Subject: Quench Arc application

Number: SRV0031

Applicability: SS755, 755 ELITE, SolarForce® 648
Any other units exhibiting these symptoms

Date: 01/18/2008

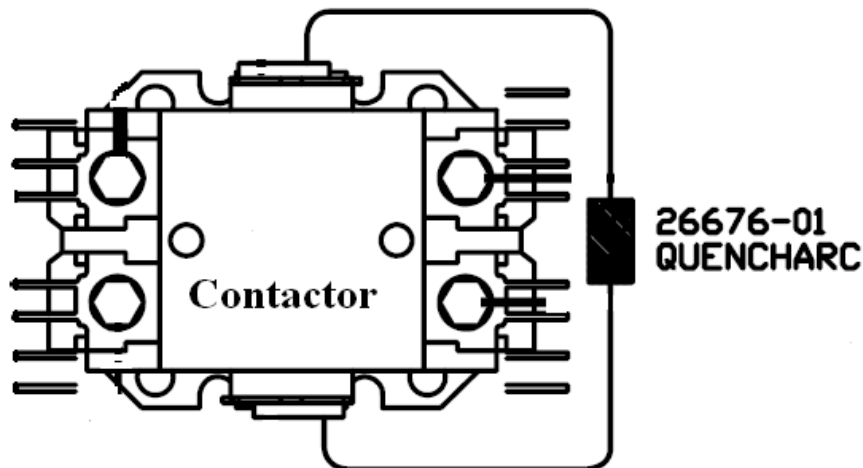
Symptoms: Unit is resetting itself during session

Unit is not displaying clean room indicator; timer automatically clearing clean room indicator

Unit display goes out, unrelated to heat

Explanation: Timers are designed to reset if electronic noise level disrupts timer operations. This can cause the explained symptoms.

Solution: Install *quencharc* (P/N 26676-01) across main contactor(s) coil as described in wiring diagram.

This should alleviate said symptoms.
